STAFF RECOMMENDATION

1611 Franklin Avenue

June 17, 2020

Application: New Construction—Addition; Partial Demolition—Outbuilding/Detached Accessory Dwelling Unit

Figure 1. 1611 Franklin Avenue.

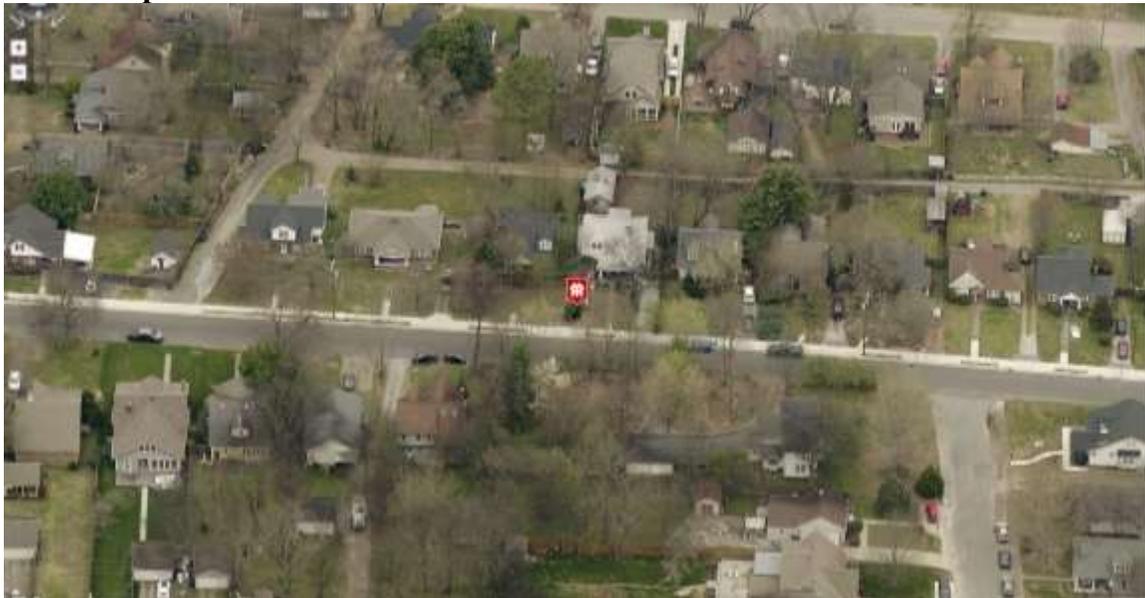
Background: 1611 Franklin Avenue is a c. 1935 stone craftsman bungalow that contributes to the historic character of the Eastwood Neighborhood Conservation Zoning Overlay (Figure 1).

SITE PLAN AND
DEMOLITION PLAN

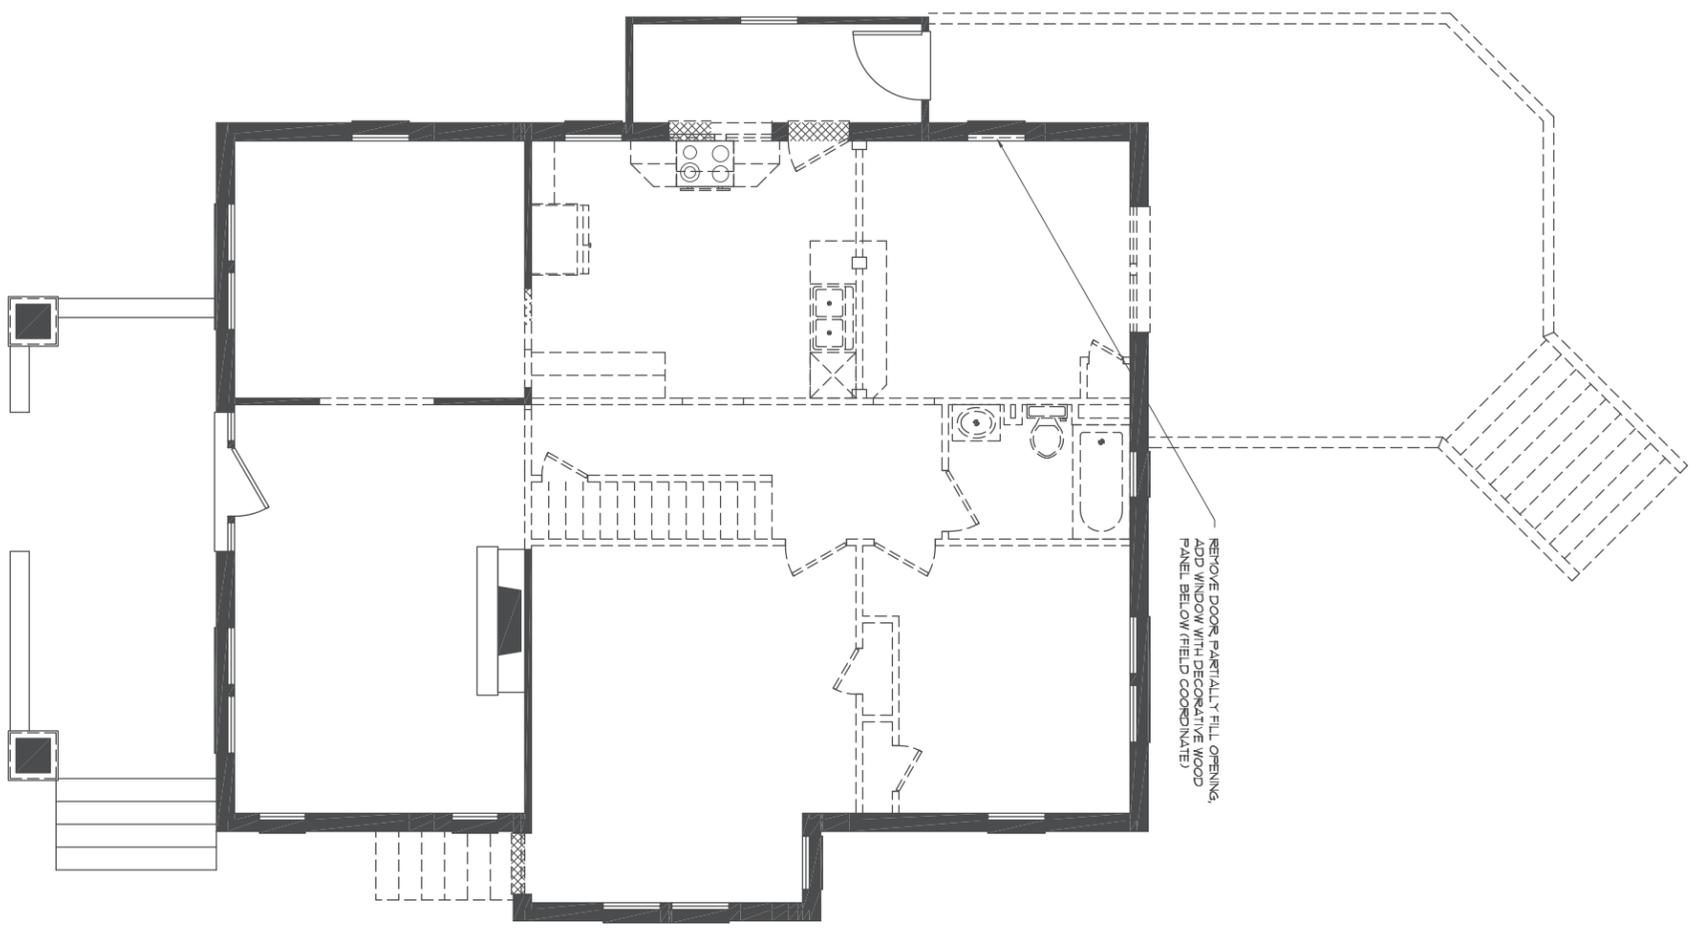
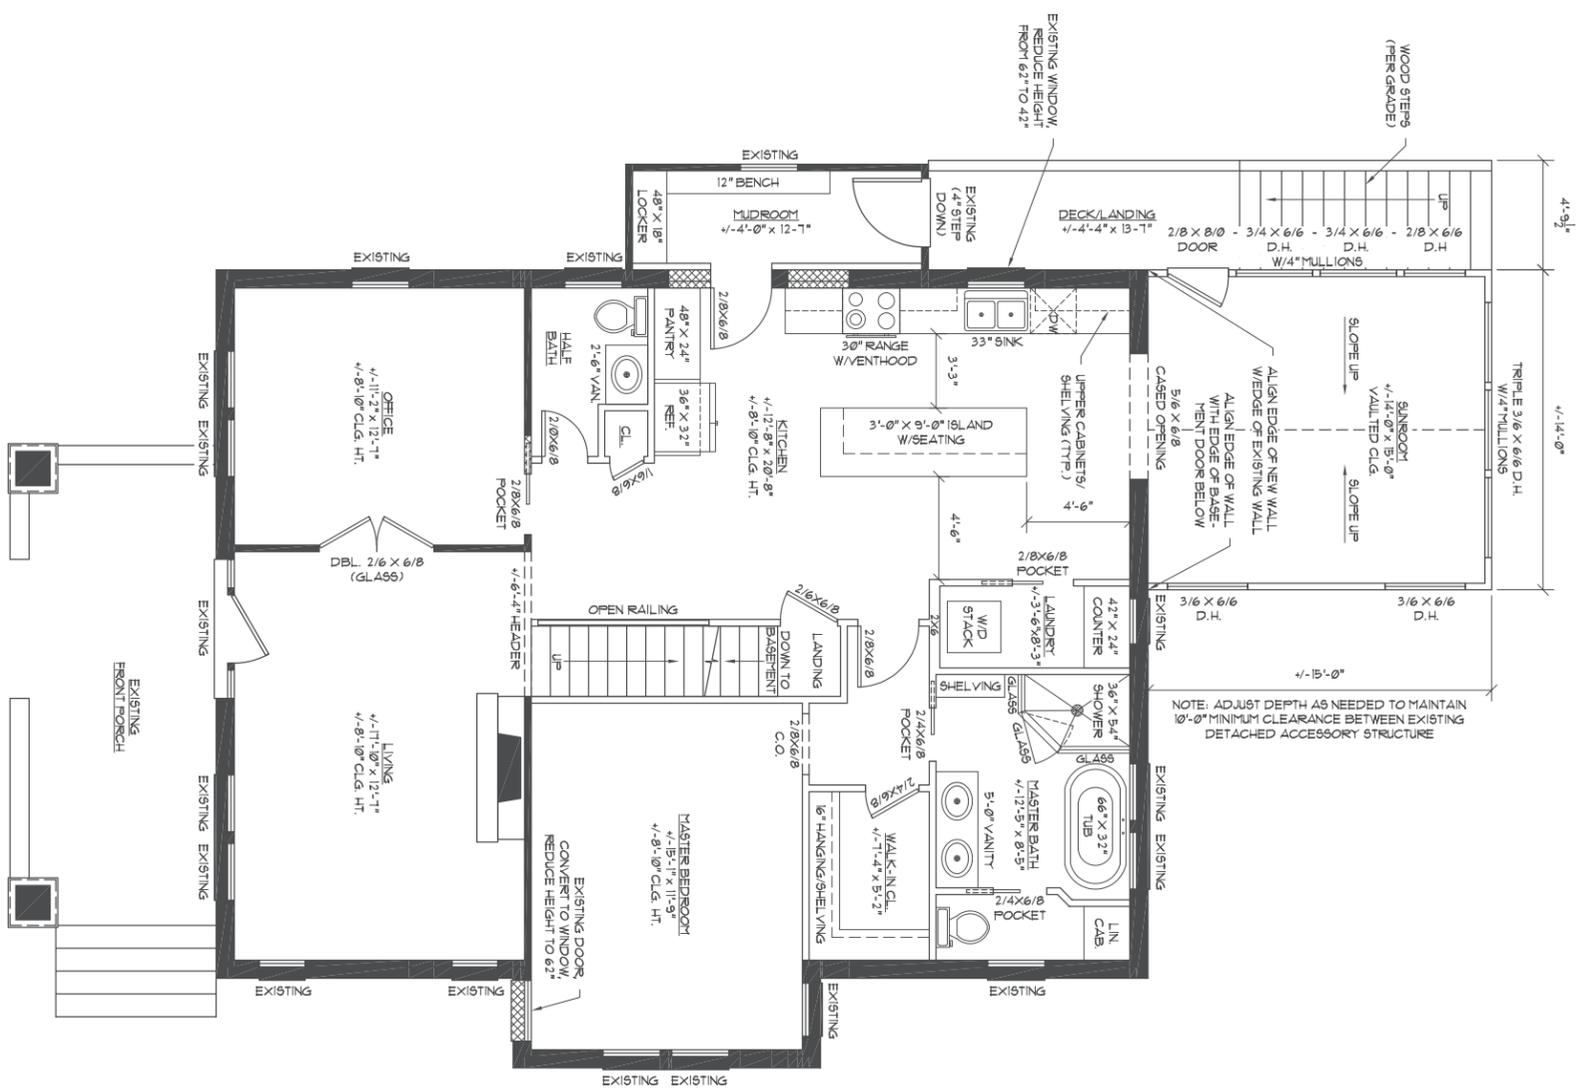
Setback & Rhythm of Spacing: The proposed addition meets all base zoning setbacks. It will be approximately eight feet (8') from the left side property line, twenty-eight feet (28') from the right side property line, and forty-five feet (45') from the rear property line. The addition will be just ten feet (10') from an existing outbuilding, whereas the design guidelines states that there should be twenty feet (20'). Staff finds this to be appropriate since the addition is just fifteen feet (15') deep, the outbuilding is existing, and neither the outbuilding nor the addition is overly large.

*The outbuilding will be just ten feet (10') from the new addition, whereas the design guidelines states that there should be twenty feet (20'). Staff finds this to be appropriate since the addition is just fifteen feet (15') deep, the outbuilding is existing, and neither the outbuilding nor the addition is overly large.

Staff finds that the proposed setbacks meet Sections II.B.1.c. and II.B.2. of the design guidelines.

Staff finds that the DADU meets Section II.B.1.h. of the design guidelines and Section 17.16.030.G.4 of the DADU Ordinance for setbacks.

EXTERIOR ELEVATIONS
 A102

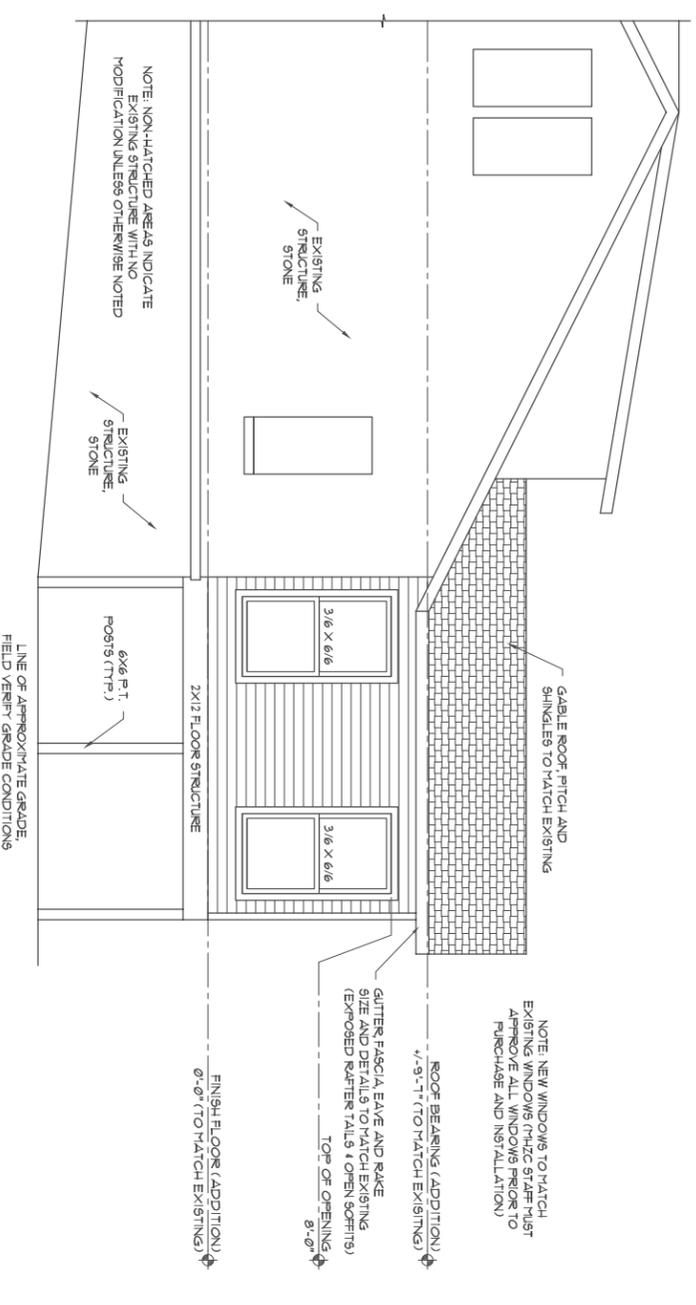
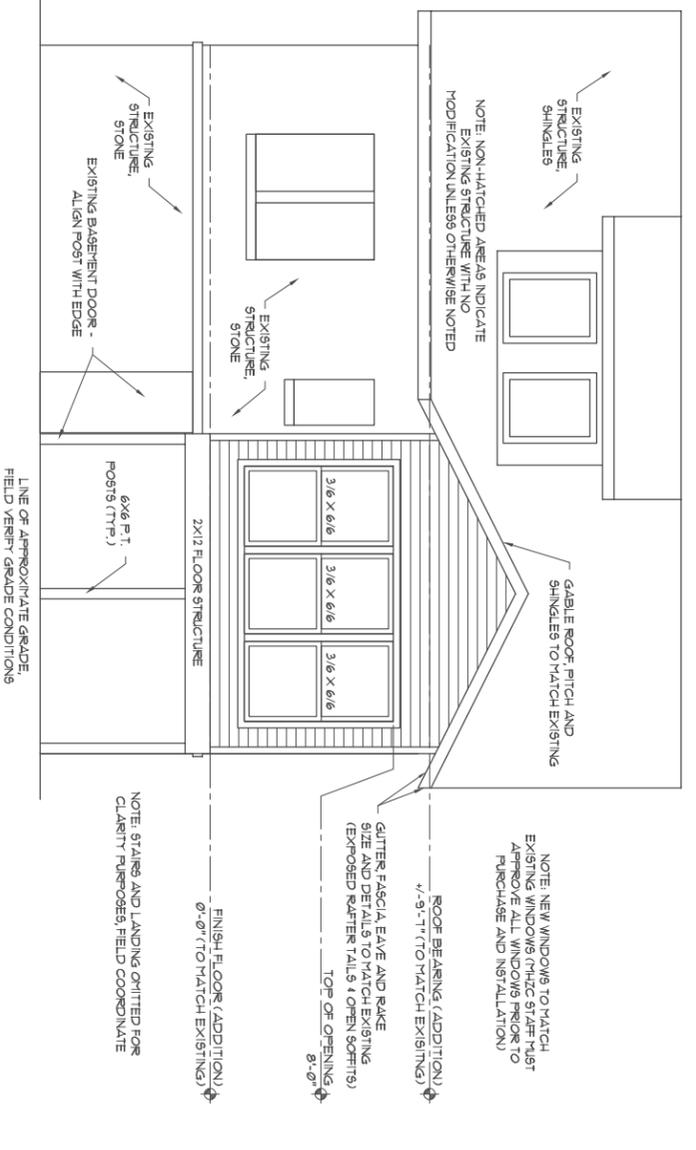
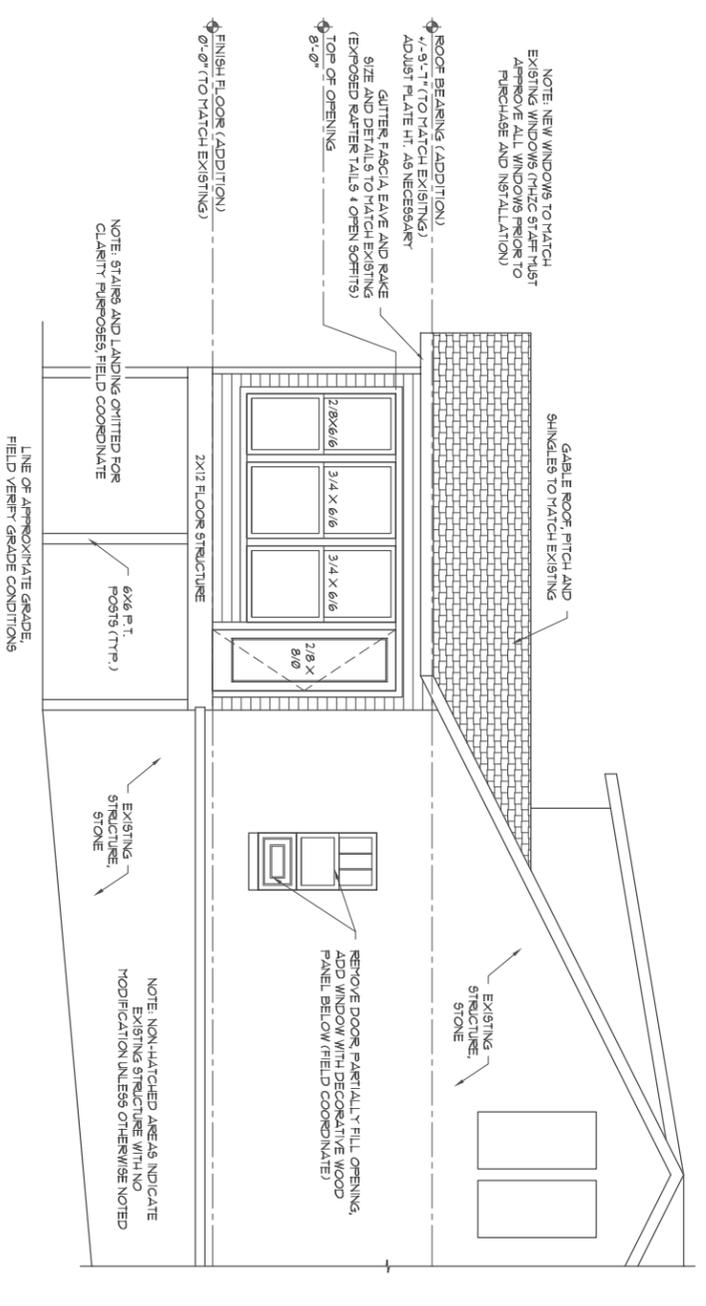
Height & Scale: The proposed addition is just one story, fifteen feet (15') deep, and two hundred and ten square feet (210 sq. ft.). Its eave height matches that of the house, and its ridge height is several feet lower than that of the historic house. The addition is not inset; however staff finds the lack of an inset to meet the design guidelines because the house is stone and the addition will be lap siding, the addition is just one-story, and the addition is only fifteen feet (15') deep. The addition will be less than twenty feet (20') from an existing garage. The addition and the garage will be ten feet (10') apart, which staff finds to be appropriate because the outbuilding is existing and neither the addition nor the outbuilding are overly large.

Design: The addition's change in materials, separate roof form, and lower height help to distinguish it from the historic house and read as an addition to the house. At the same time, its scale, materials, roof form, and fenestration pattern are all compatible with the historic character of the existing house.

Roof form: The addition will have a gabled for with a slope of about 6/12. This simple roof form is appropriate to the historic house.

Proportion and Rhythm of Openings: No changes to the window and door openings on the existing house were indicated on the plans. The addition will serve as a sunroom, and the windows are vertically oriented and proportioned appropriately. There are no large expanses of wall space without a window or door opening.

Staff recommends approval of all windows and doors and the roof shingle color prior to purchase and installation.

Appurtenances & Utilities: No changes to the site's appurtenances were indicated on the drawings. The location of the HVAC and other utilities was also not noted. Staff recommends that the HVAC, if relocated, be located on the rear of the house, or on the side beyond the house's midpoint.
